## Addendum No. 2

**DATE:** January 8, 2021

**TO:** Prospective Bidders  
**SUBJECT:** Addendum No. 2  
**PROJECT NAME:** Respiratory Therapy Build-Out  
**JJC PROJECT NO.:** B20036

13 Typical Headwall at Lab and Exam Room Enlarged Elevation  
3/4" = 1'-0"

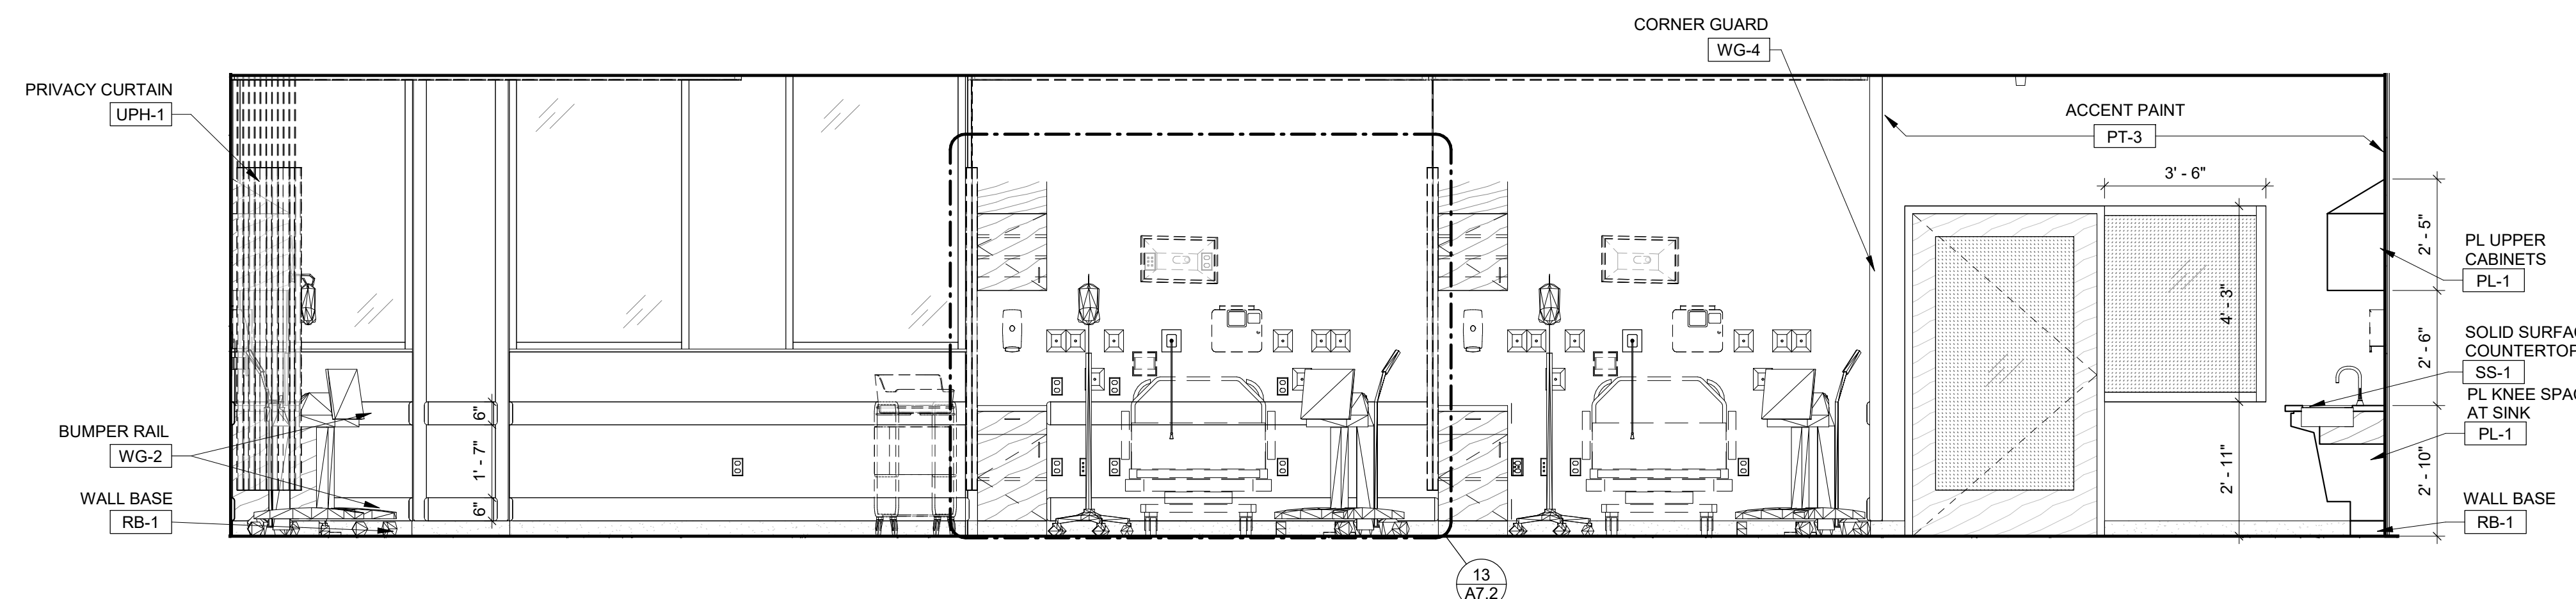
9. *The Electrical drawings show (8) receptacles at each Lab Hospital Bed. However, details 1-3/A7.2 show a maximum of (6) receptacles at each bed, sometimes less. Please confirm the quantity of receptacles at each bed in Lab 1019D*

- a) *The Architectural details 1, 2 & 3 on A7.2 Details show a maximum of six (6) receptacles at each bed, some with less.  
The electrical drawings are showing eight (8) at each bed.  
Please confirm the quantities.*

**Individual elevations may have equipment blocking the view of the receptacles. Refer to 13/A7.2 for the Typical Headwall Enlarged Elevation for all beds in the Lab 1019D and Exam 1019E. The elevation has been updated to reflect an additional receptacle for the monitor for a total (9) power receptacles, as well as an "E" designation to clearly show which are Emergency Power per the electrical drawings. See attached sheet A7.2.**

**Individual elevations may have equipment blocking the view of the receptacles. Refer to 13/A7.2 for the Typical Headwall Enlarged Elevation for all beds in the Lab 1019D and Exam 1019E. The elevation has been updated to reflect an additional receptacle for the monitor for a total (9) power receptacles, as well as an "E" designation to clearly show which are Emergency Power per the electrical drawings. See attached sheet A7.2.**

A11.0

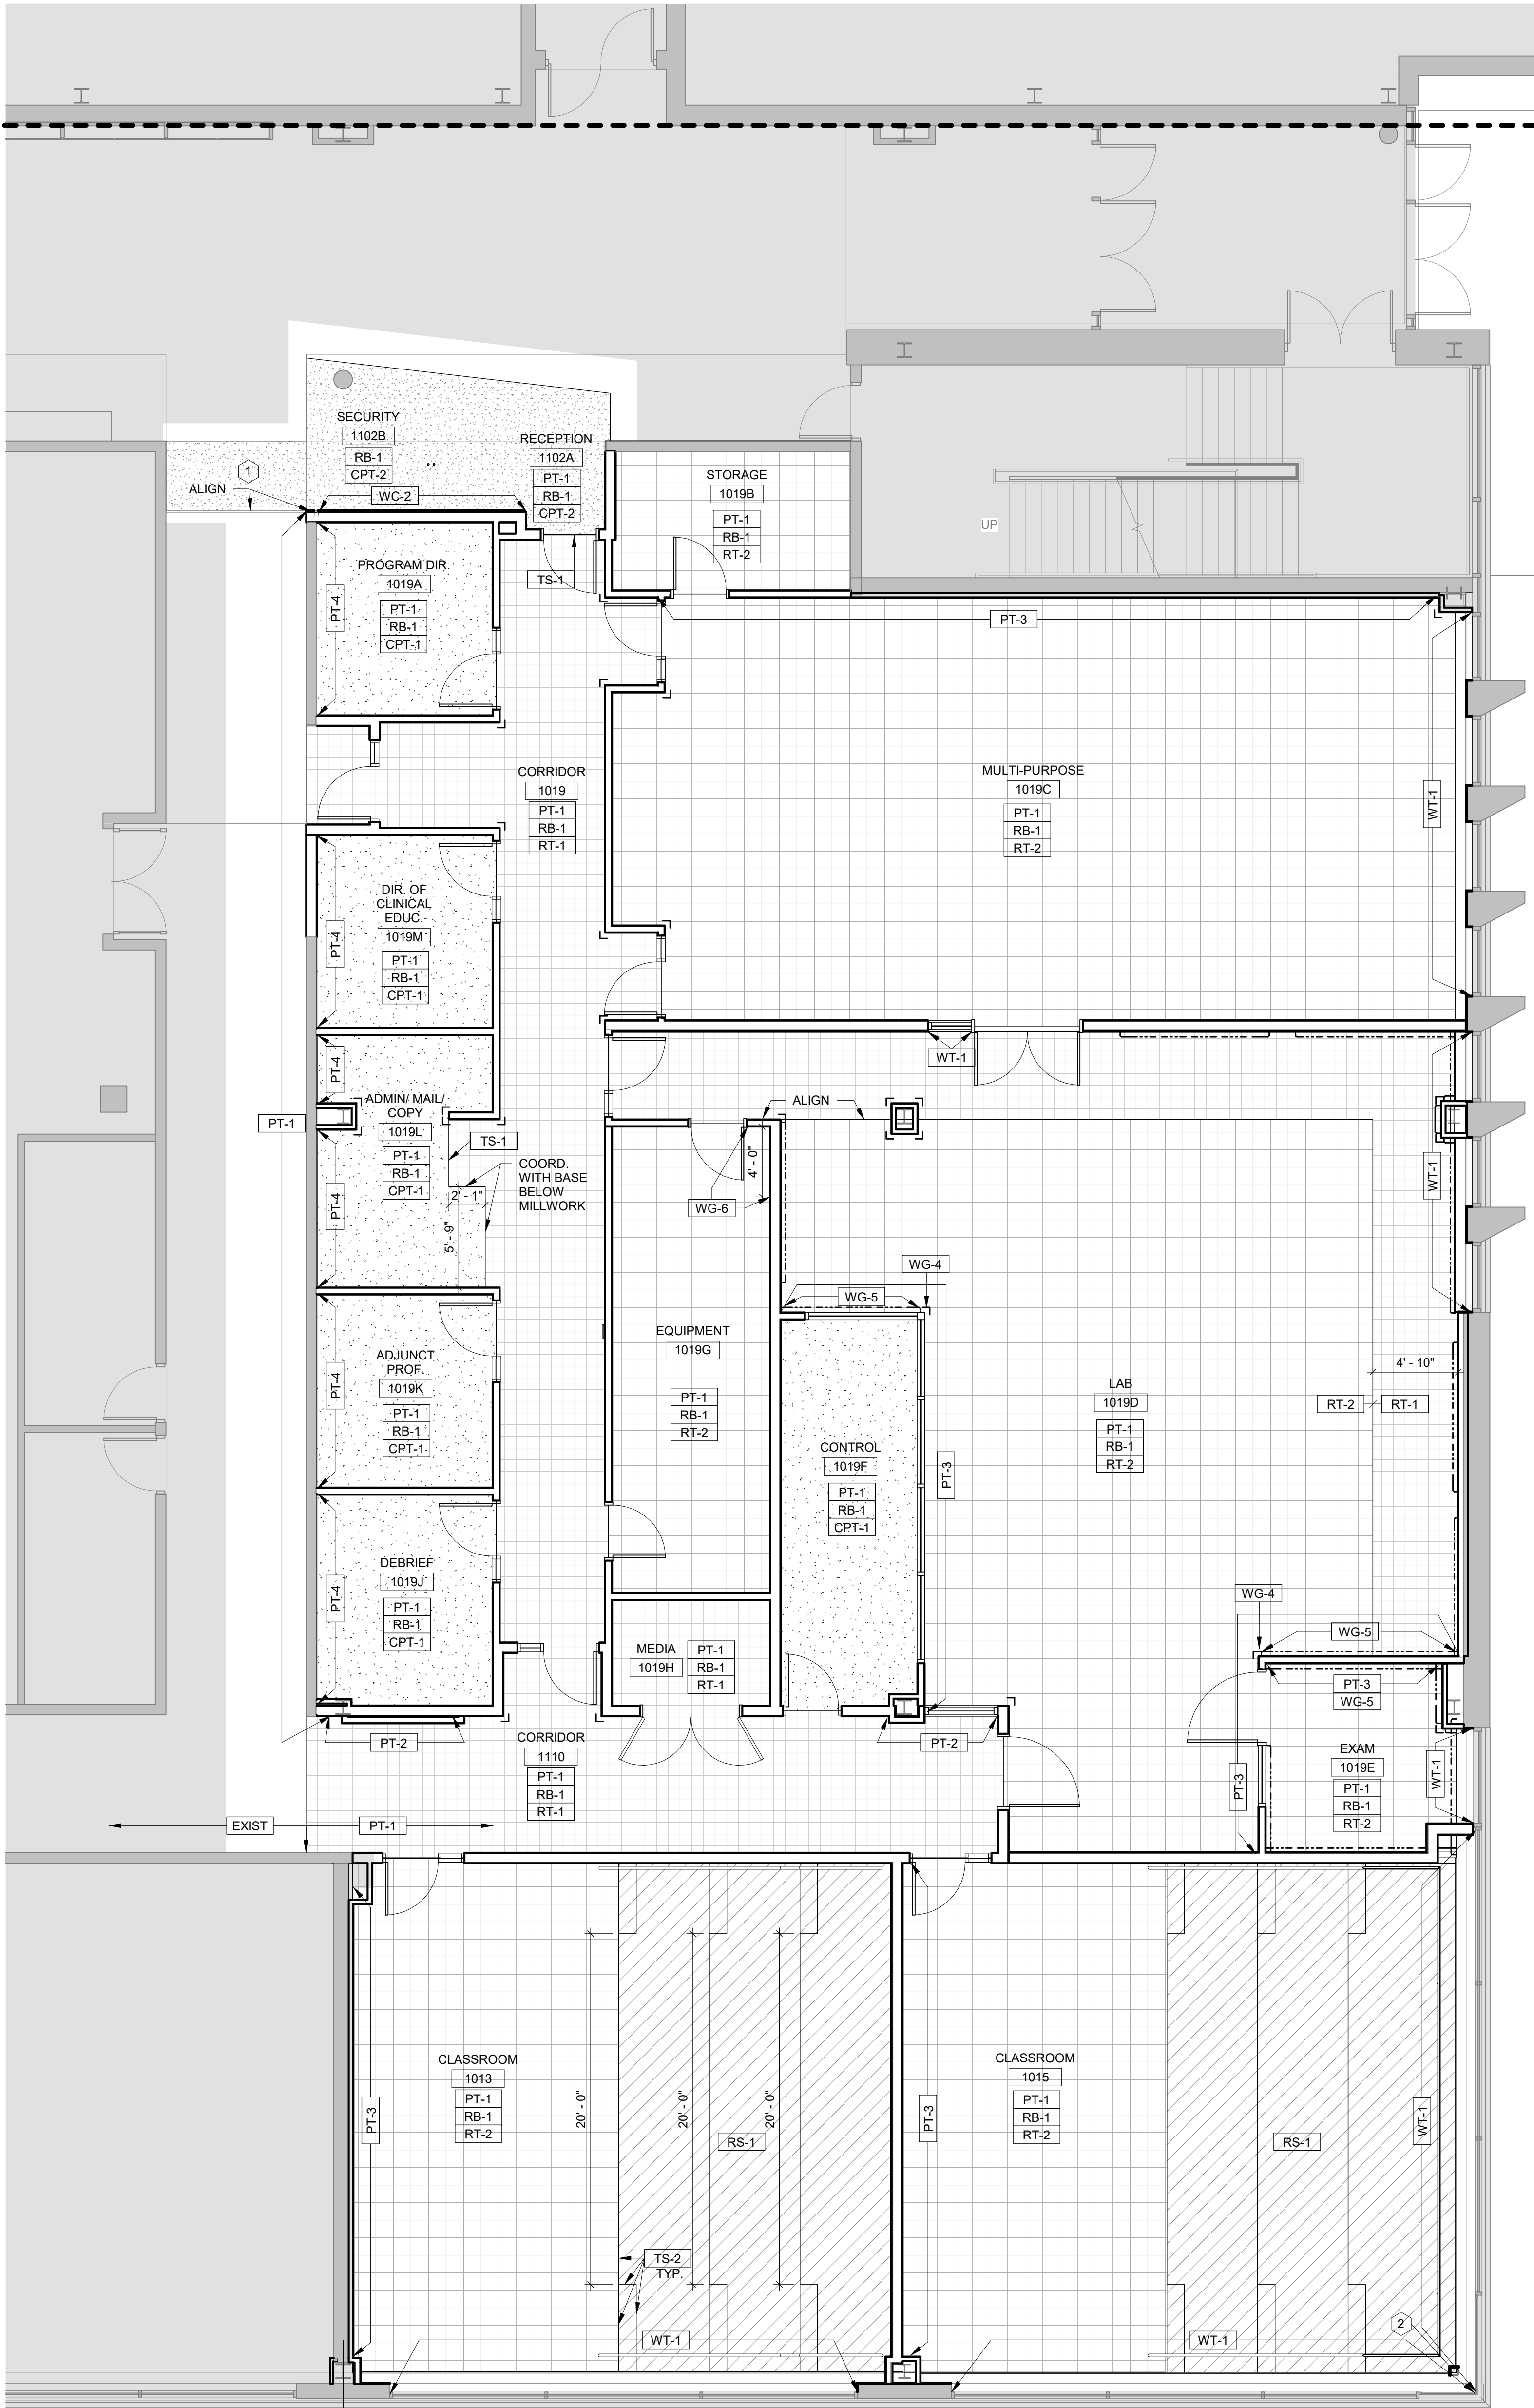
5. *Finish schedule on A11.0 shows WD-1 as "Match Existing Wood Veneer at Stair". Can you share any photos or specifications for this existing wood veneer?*

11. *Glass type G-2 is noted to be etched per A11.0 Finish Material Schedule. Please advise if this is a full height/width acid etch of the glass or some type of etched pattern glass.*

**Provide maple veneer as described in updated schedule on sheet A11.0.**

**The etching shall be uniform and full height and width of glass. Refer to requirements of Type G-2 as described in Specification Section 08 8000 2.02B.**

E2.01

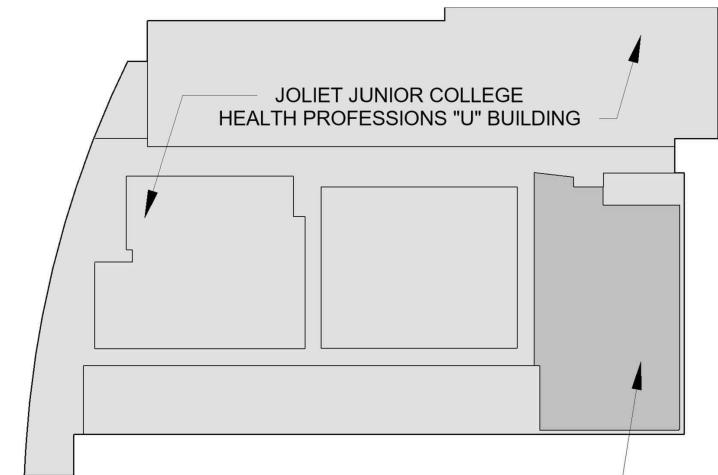
- a) *Could you indicate the location of the existing Lutron Lighting Control Panel?*

- b) *Can you furnish a single manufacturer's model number for the lighting control devices you want used, so we can see what it is you want the controllers to do? We can't tell by the plans or generic specifications if the wall switches are line voltage or low voltage. Or, can you furnish a Lighting Control Sequence of operations matrix?*

**6. CONNECT ZONED LIGHTING TO EXISTING LUTRON PANEL  
U1114B**

**Panel is located in electrical room U1114. This room is approx. 185 ft west from the center of the respiratory therapy shell space to the center of electrical room U1114.**

**Lighting control sequence of operations matrix have been provided to assist contractor in selecting appropriate lighting control devices. Refer to fixture symbols on plan E2-01 to determine specific device type in each sequence. Wall control devices have been revised; refer to sheet E2-01 for additional clarity.**
